## PLANNING COMMISSION STAFF REPORT

DATE: OCTOBER 14, 2015

SUBJECT: FRANK M. HOMES INC, REQUESTING A MAJOR ARCHITECTURAL APPROVAL FOR A 2,913-SQUARE FOOT HOUSE ALONG A MAJOR THOROUGHFARE AT 2700 NORTH SUNRISE WAY, ZONE R-1-C (CASE 3.3849 MAJ) (GM)

**Site and landscaping Plan**

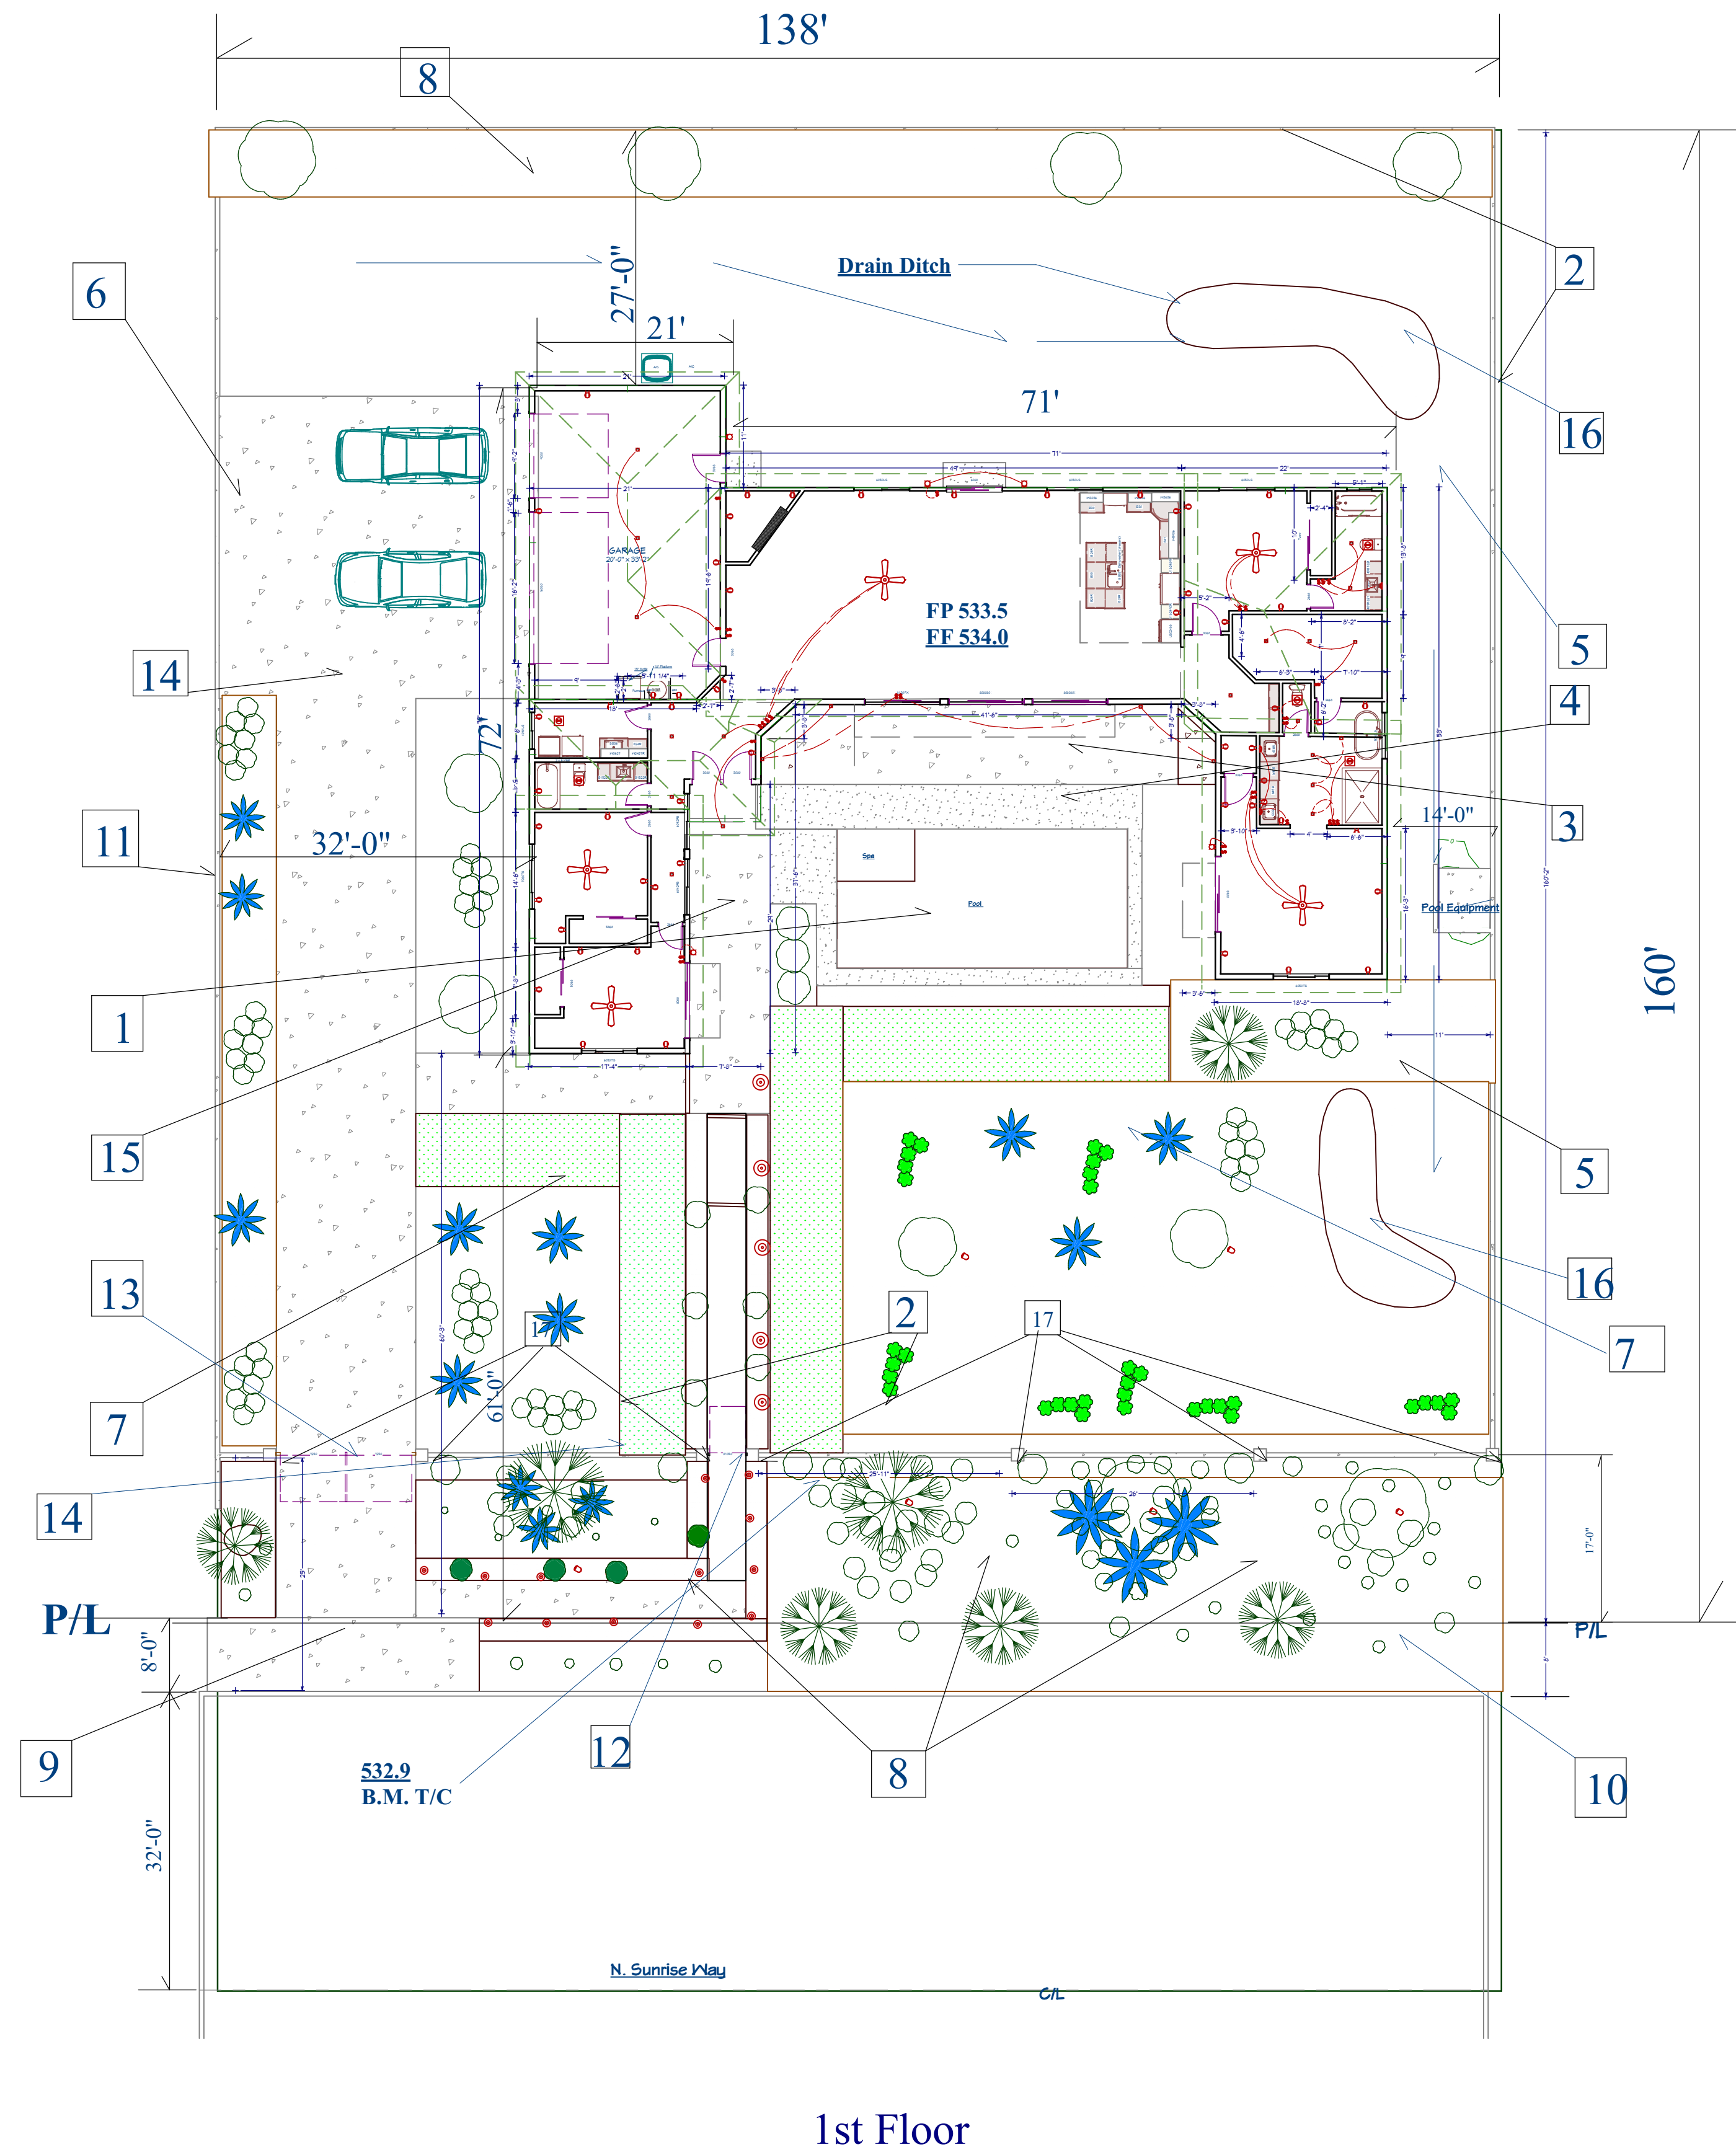
Staff is recommending that Engineering Condition of Approval ENG 7 not be deferred and a new five (5) foot wide sidewalk be constructed adjacent to existing curb along the lot frontage. Dedication of ten (10) feet is required for the ultimate right-of-way width of North Sunrise Way; however there are no immediate plans to widen the street. The east side of the 2700 block of North Sunrise Way consists of 9 lots with 5 lots developed and 4 vacant. Only one developed lot currently has a partial sidewalk. A meandering sidewalk is present along the west side of the street along the frontage of The Enclave. Staff believes that the installation of the sidewalk on the east side of North Sunrise Way will provide greater pedestrian connections within the neighborhood. The applicant has been made aware of this request and will comply with the direction of the Planning Commission.

- Italian Cypress used with desert landscaping;
- Lack of proportion/scale of frontage landscaping;
- Grouping/clustering of plant material – should be “sweeping” – breakup groupings;
- Design of wall and how it matches the character of the house.

The applicant has revised the plan to include the elimination of Italian Cypress trees replaced with two (2) Olive trees and two (2) lemon trees; the grouping and proportions of the plants in the area between the wall and curb has been revised to provide increased scale and massing of plants in beds with gravel and rubble; the front wall has been redesigned to include seven (7), six foot tall stacked stone columns with cap to break-up the long wall and tie-in elements of the new house. Staff believes that the revised wall and landscape plan meets the direction provided by AAC.

1. Entry gate has been pushed back to 25' from the curb to provide adequate space.
2. Front block wall has been redesigned to include tan split face blocks, columns wrapped with Eldorado Stack Stone and matching column caps.
3. Cypress Trees have been removed and replaced with Olive Trees.
4. Plant clusters have been changed and enhanced with additional water tolerant plants.
5. Turf area has been reduces by over 60% to only two borders.
